Recall Campaign Bulletin

Campaign No. 2022120016, January 2023

SUBJECT: Model GLE and GLS (167 platform) vehicles

Replace the Steering Coupling Locking Screws

Figure 1

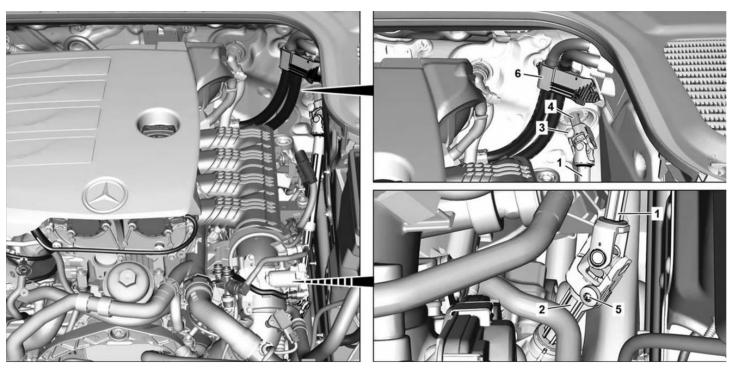
- 1. Replace bolt at upper and lower universal joint of the steering coupling (Figure 1,2).
 - Bolts shall be accessible from engine compartment at the top.
 - Turn steering column until both bolts are accessible.
 - Steering coupling bolt to steering shaft or rack-and-pinion steering **42 Nm**.
